DUKE POWER COMPANY
OCONEE NUCLEAR STATION
ATTACHMENT 1
TECHNICAL SPECIFICATIONS

TECHNICAL SPECIFICATIONS
MARKED UP COPY

The technical justification describes the resolution of four general problems associated with the current HPI Technical Specifications. A detailed description of the changes to the current technical specifications, as well as revisions to the Bases for Specification 3.3.1, is provided. A summary flow diagram of the Oconee Emergency Core Cooling System (ECCS) is included as Figure 1. In addition, a new specification is proposed to address operability requirements for the main steam atmospheric dump valves (ADV's). This specification is being proposed because the ADV's are being credited to depressurize the steam generators in the revised small break LOCA analyses. Finally, a minor revision to Specification 3.3.2 for the LPI System is being proposed to clarify that the Reactor Building Emergency Sump isolation valves are remote-manual valves.

Figure 1

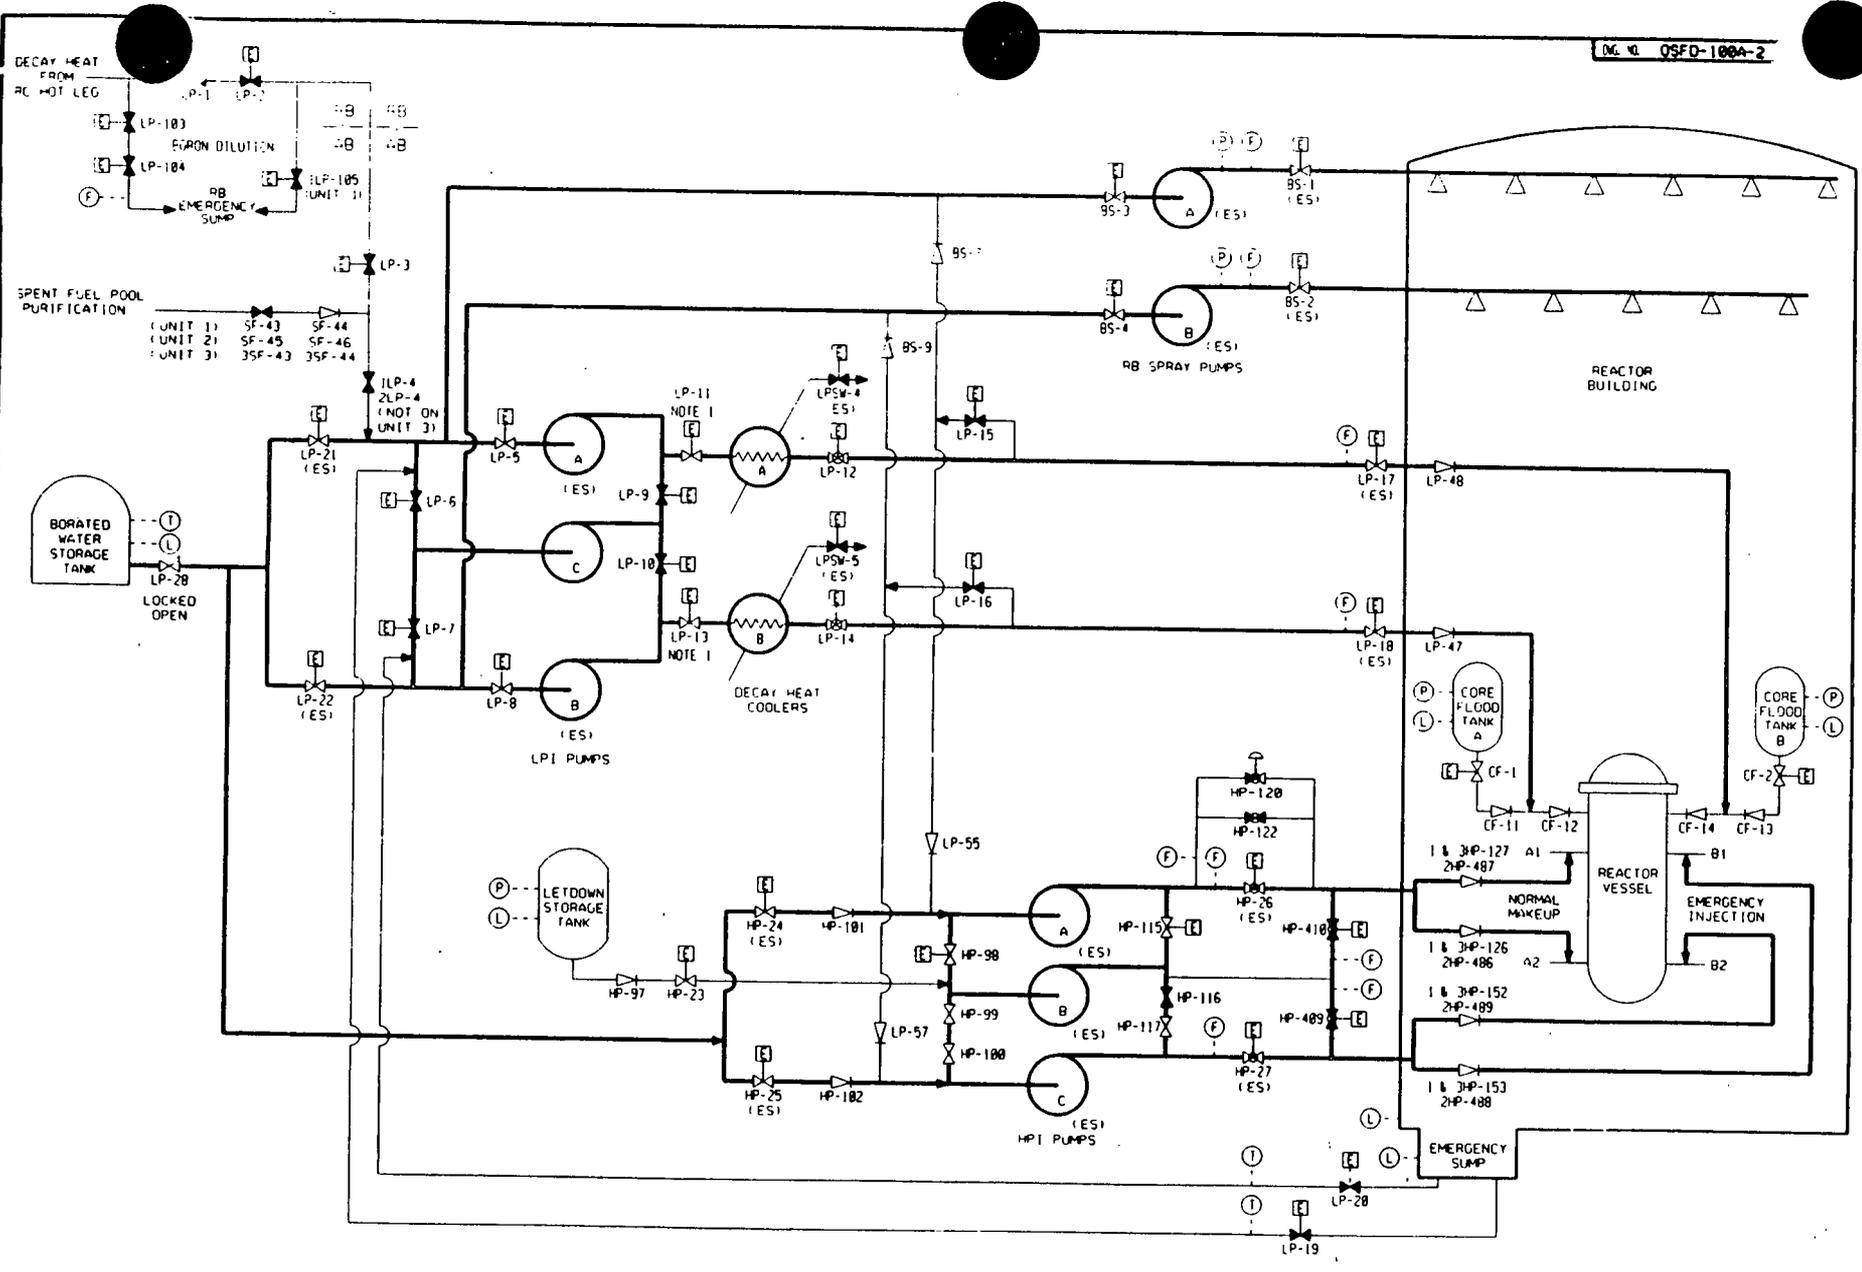
The section in the BASES for Specification 3.3.1 which addresses the HPI System has been replaced with a greatly expanded description. ECCS requirements, redundancy and train separation requirements, and an explanation of the proposed actions and completion times for Specification 3.3.1 are included in the revised BASES. These proposed BASES, which are self-explanatory, are intended to provide more detailed guidance to operators who will apply Specification 3.3.1.

Section 15.14 of the Oconee UFSAR will be revised to reflect the results of the revised SBLOCA analyses which support this Technical Specification change. Section 10.4 of the Oconee UFSAR will be revised to address use of the main steam atmospheric dump valves during a SBLOCA.
